CITY OF WASHINGTON, ILLINOIS

City Council Agenda Communication

Agenda Item: Preliminary Plat Resolution – Trails Edge Sections 9 and 10

Agenda Item: Trails Edge 9&10 Drainage

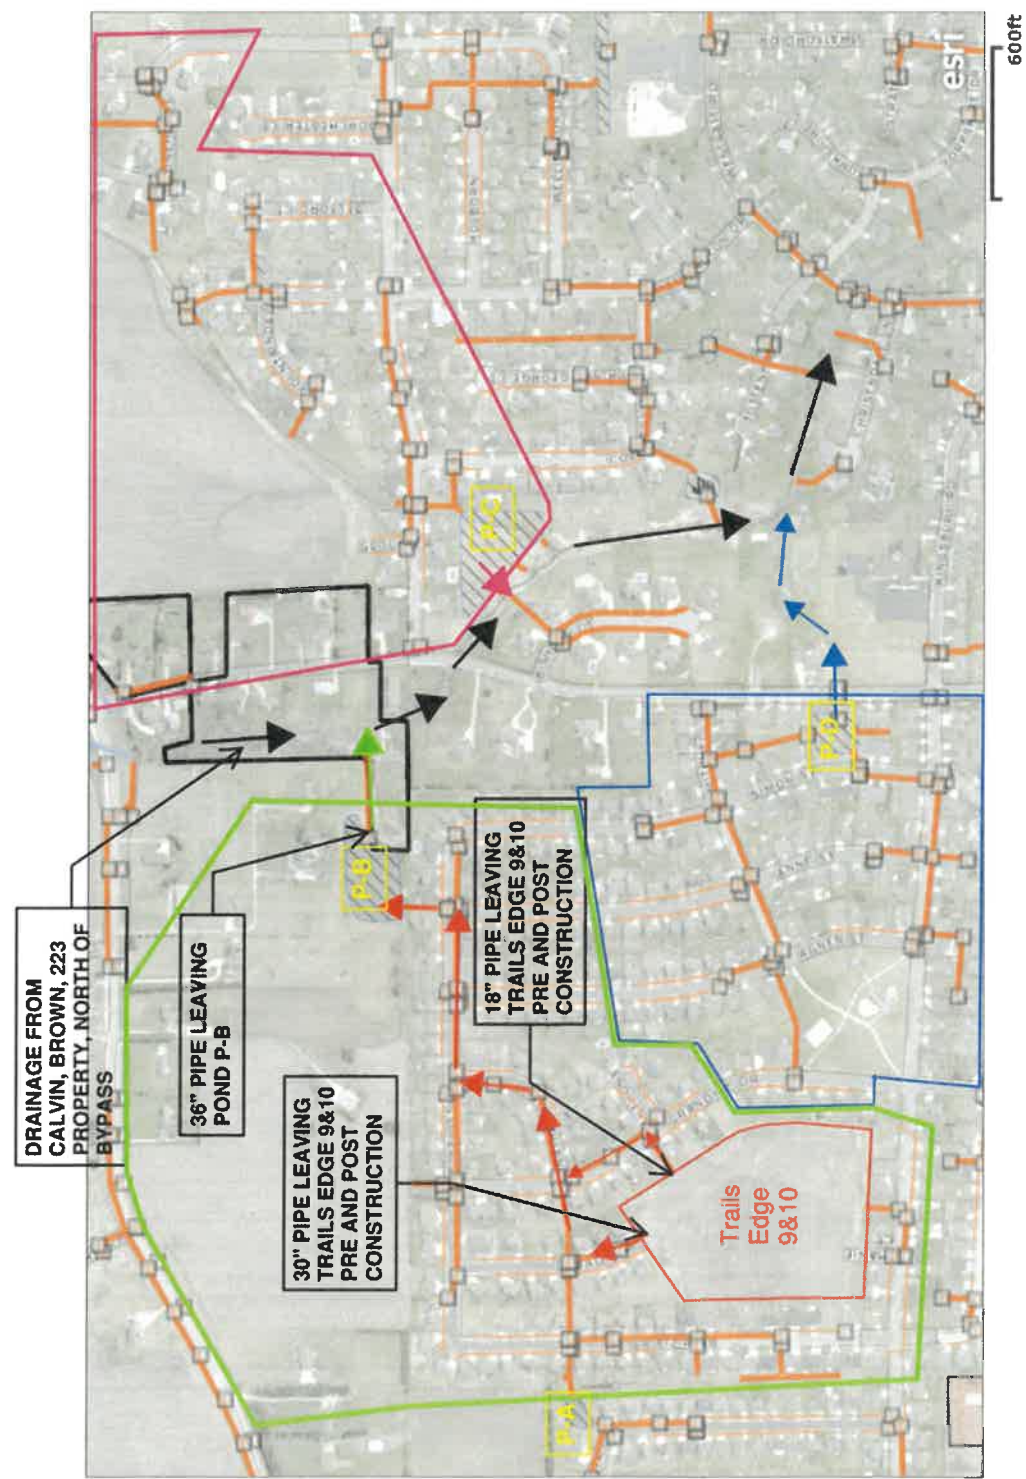
Existing Conditions: The Trails Edge 9&10 Area is currently a field that has inlets to drain the area. These inlets collect a majority of the stormwater and convey it to a 30” pipe that heads north out of the area on Debates. The water will pond in the field on top of the inlet areas until it can drain through the 30” pipe. Any stormwater that does not collect in the inlets drains to the rear yards along Patricia and Grandyle. There is an inlet in the rear yards of 728/730 Grandyle that collections another portion of the Stormwater. From past meetings, it was expressed to staff that during large storm events this inlet can have several feet of water above the inlet. Both of these storm sewers (30/18) travel through the pipes of the storm system and into the pond north of Kelsey between Anne and Simon Streets (P-B).

Proposed Conditions: The developed area will have more runoff from the homes, pavement, and concrete. However, the grass will also slow water down that falls in the grass area but will drain a majority of the area to the roadway itself. The roadway is used to convey the stormwater to the inlets which connect to the same 30” pipe that heads north out of the area on Debates. The water will pond in the roadway on top of the inlet areas (Not exceeding curb height per code) until it can drain through the same 30” pipe (The Roadway Effectively acts in place of a 100 Yr Flood route stormwater easement). There will be less water draining to the rear yards of 728/730 Grandyle which will reduce the height of the water above that inlet during storm events. Both of these storm sewers (30/18) travel through the pipes of the storm system and into the pond north of Kelsey between Anne and Simon Streets (P-B). The Trails Edge 9&10 project will not increase surface drainage issues for anyone in the surrounding roadways as all stormwater is contained in the pipe system until the pond.

Review: This portion of Trails Edge is one of the furthest away from detention pond P-B. This means that during storm events, this is the last water to get to the basin. The water that is sitting in the roadway on Trails Edge 9&10 will be some of the last water to reach the Pond P-B and water will already be leaving that basin through the pipe or spillway before it even gets to the pond.

In both pre and post construction, the retention pond is releasing water through the same pipe into the Dallas channel. During smaller events (<25 yrs), the pond discharges through a 36” pipe. During larger events (25-100 yr), the pond is designed to engage the overflow spillway which drains into the same Dallas Channel. Rain events that exceed 100 yr events are not designed for as they are considered act of gods. The pond discharge to Dallas will not be affected by this additional area until a storm exceeds the 100 Yr Storm which we do not require design for. The retention basin was sized to include Trails Edge 9&10. When the original design was done, a buildout runoff coefficient was assumed for the entire development as was established by best practice. The same is done now for generalized development. The stormwater, from up to a 100-year event, from this development will not adversely affect the stormwater drainage of other residents in the Trails Edge subdivisions.
